## **BAYVIEW HEIGHTS SUBDIVISION,** **PIERCE ADDITION TO**

APPLICATION NUMBER 7 DATE December 15, 2005  
APPLICANT Bayview Heights Subdivision, Pierce Addition To  
REQUEST Subdivision

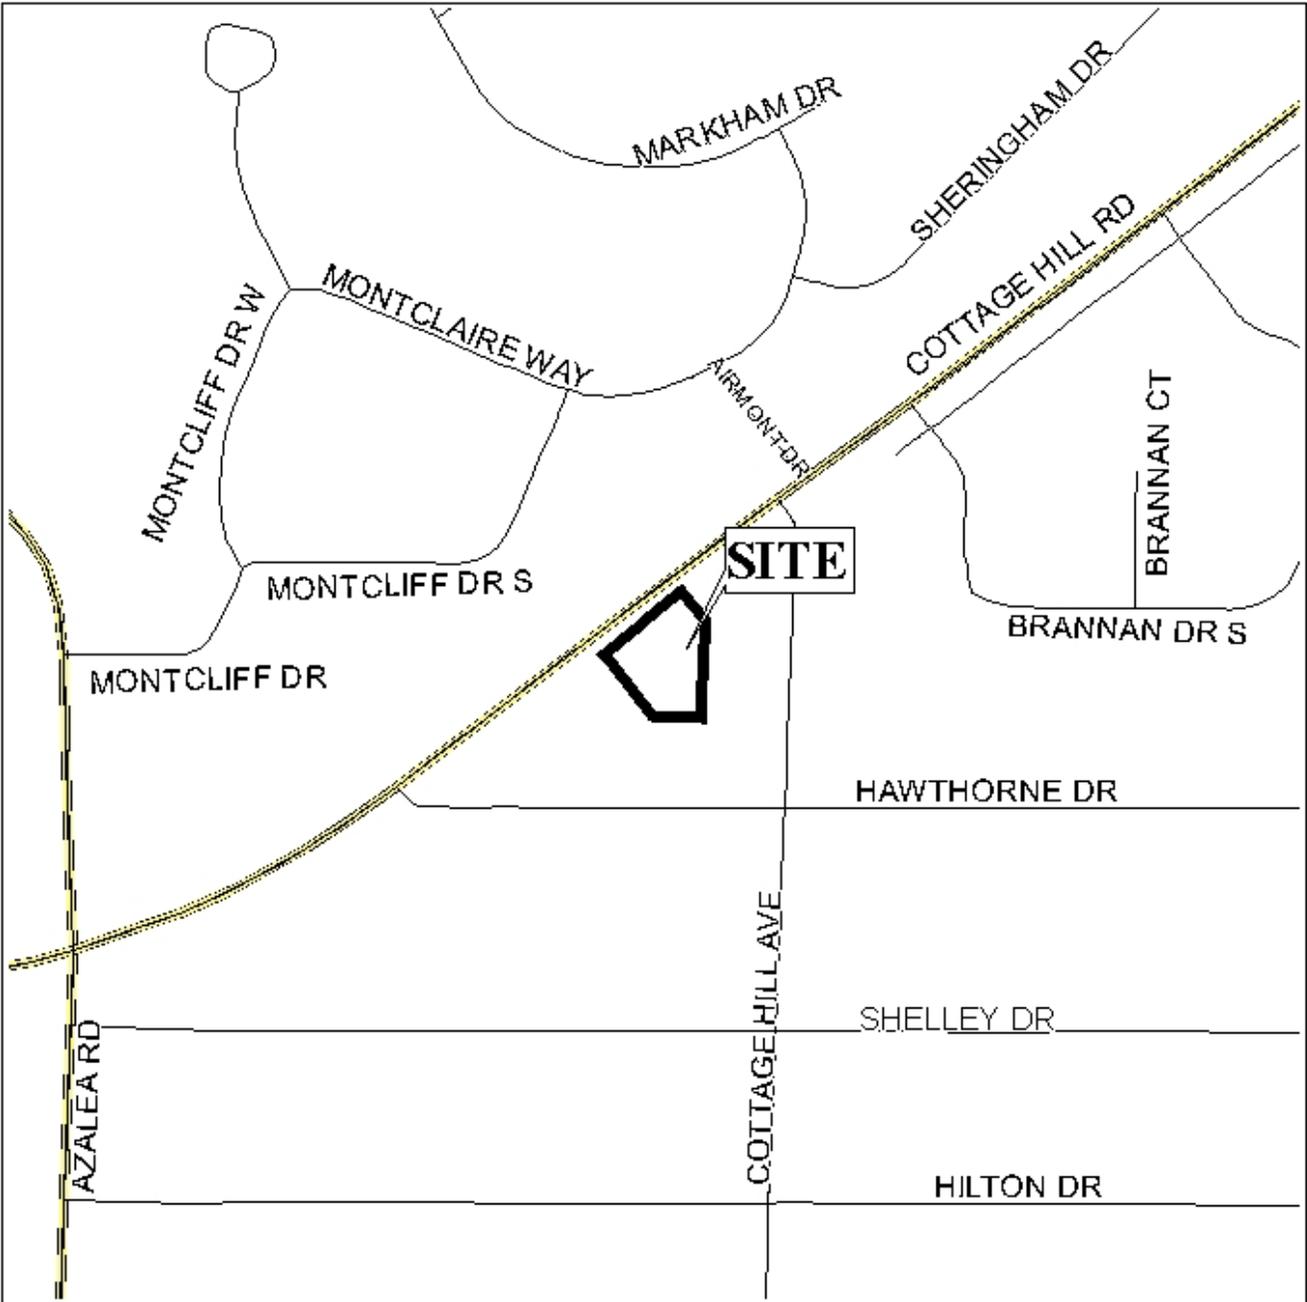
The site fronts Cottage Hill Road, which has an 80-foot right-of-way, and requires a 100-foot right-of-way as depicted on the Major Street Plan; thus sufficient dedication to provide 50 feet from the centerline of Cottage Hill Road should be required. Furthermore, the 25-foot building setbacks should be measured from the dedication and shown thus on the final plat.

The legal description of the site indicates that the entire parent parcel is not included in the application, and that a triangular portion of the original Lot 11 (Bayview Heights) was conveyed to the owners of Lots 16 and 17 (Bayview Heights) in 1969, after the introduction of the Subdivision Regulations. Furthermore, while this property is excluded from the legal description of the subject property, it is not included in the legal description of the parcel including Lots 16 and 17.

It should also be noted that some adjacent property owners did not receive notification; thus additional fees and mailing labels should be submitted to correct this situation.

Based on the preceding, it is recommended that this application be held over to allow the applicant to include the entire parent parcel in the application, and to notify all adjoining and facing neighbors. As the triangular property contains far less land than can comprise a lot of record, the application should include at least one of the lots (16 or 17) that it has been conveyed with. Revised plats, fees, and mailing labels must be received by December 27<sup>th</sup> in order to be considered at the January 19<sup>th</sup> meeting.
